MOG2 grid design

Elia MOG2 workshop – 14 October 2022 - Brussels

Federal Development Plan 2024-2034 proposal does not create sufficient grid capacity to tap into offshore potential

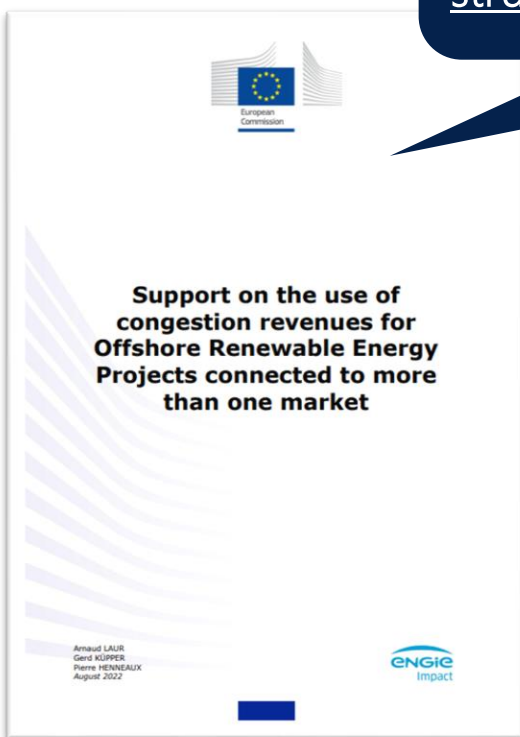
**Structural shortage
in grid capacity**
Especially from island to coast 1,4GW short

OBZ is a way to allocate grid capacity in case of a shortage. It does not solve the underlying shortage

Option 1

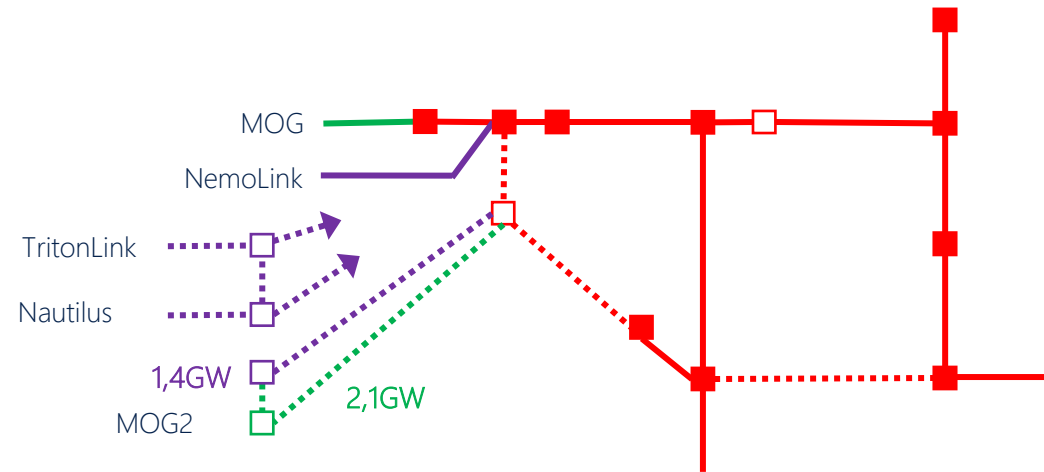
Nautilus inland

- Use currently planned MOG2 design for 3,5GW OWP
- Direct Nautilus to Gent-Antwerp-Brussels area:
 - Corridor is feasible for TritonLink, so also feasible for Nautilus (similar technology);
 - Bundling of TritonLink and Nautilus corridors might reduce local impact
- Coupling Nautilus and MOG2 later in time when DC technology is ready

Option 2

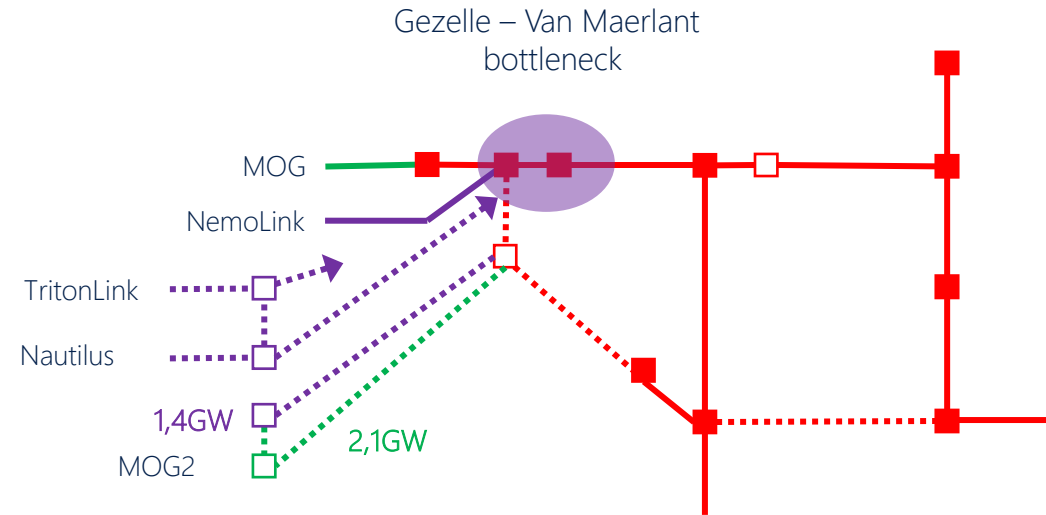
Faster elimination of Gezelle-Van Maerlant bottleneck

Nautilus to Stevin-corridor

- Elimination of the bottleneck on Stevin now planned for ~2035
- Accelerate this project and plan commissioning by 2030
 - Creates sufficient access capacity for both Nautilus and 3,5GW offshore wind on Stevin+Ventilus corridors
- Connect Nautilus to the Stevin corridor

Option 3

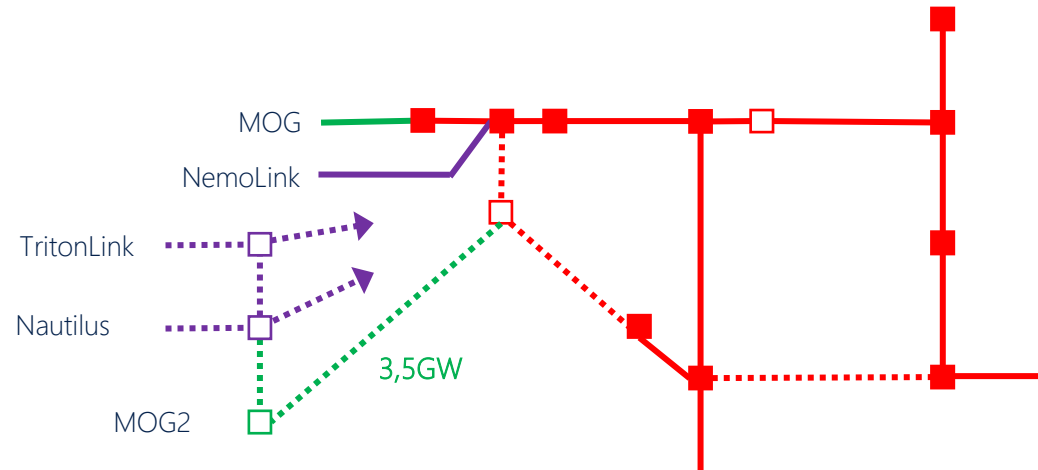
Extra 220kV AC for MOG2

Nautilus inland

- 4 extra 220kV AC cables for MOG2: 3,5GW instead of 2,1GW
- Direct Nautilus to Gent-Antwerp-Brussels area
- No AC/DC convertor required on Ventilus might reduce local impact

Option 4

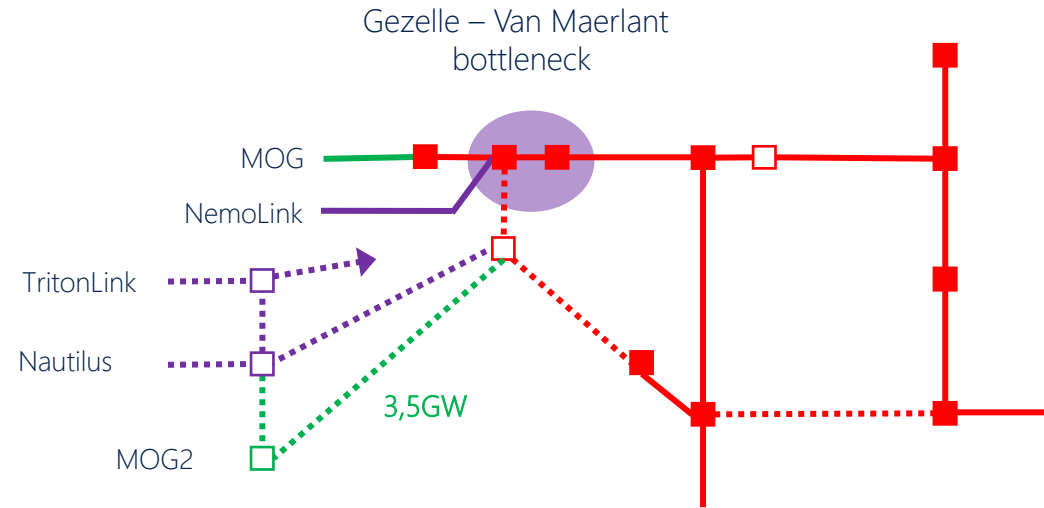
**Extra 220kV AC
for MOG2**

**Faster
elimination of
Gezelle-Van
Maerlant
bottleneck**

- Elimination of the bottleneck on Stevin now planned for ~2035
- Accelerate this project and plan commissioning by 2030
 - Creates sufficient access capacity for both Nautilus and 3,5GW offshore wind on Stevin+Ventilus corridors
- 4 extra 220kV AC cables for MOG2: 3,5GW instead of 2,1GW

Option 5

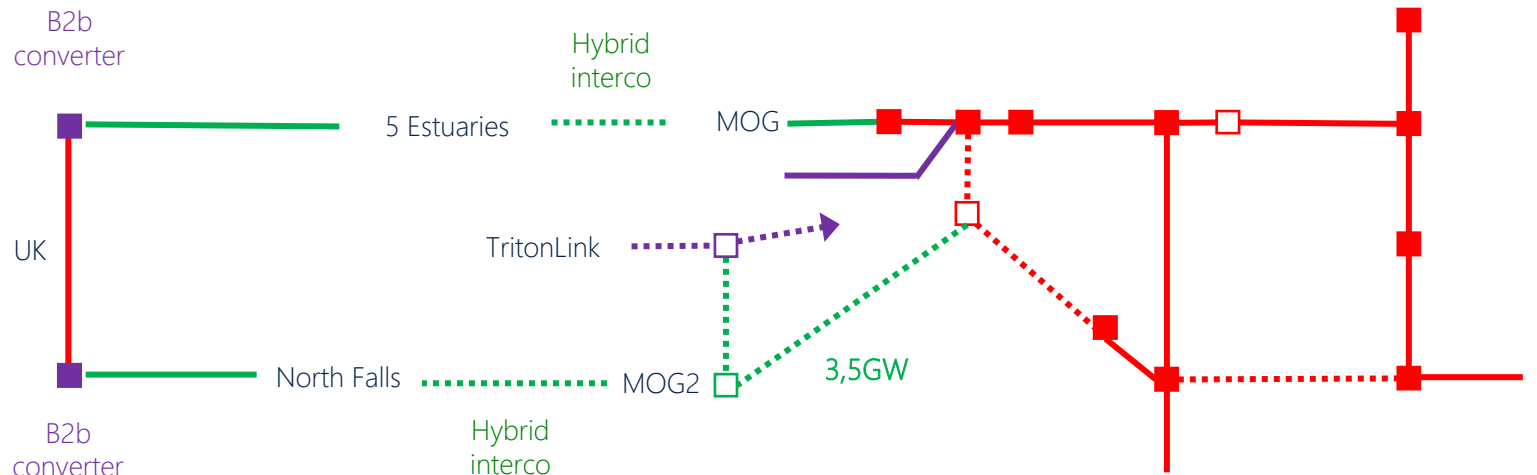
Replace Nautilus with different hybrid interconnector(s)

- Connect the most Northern OWF in BE with the most Southern OWF in UK
- These distances of new connections are much smaller, and they will create a hybrid interconnector between UK & BE, allowing for import/export in case of low winds
- With a more limited investment (short cable + back-to-back converter), an interconnection could be made that will truly increase cable utilisation
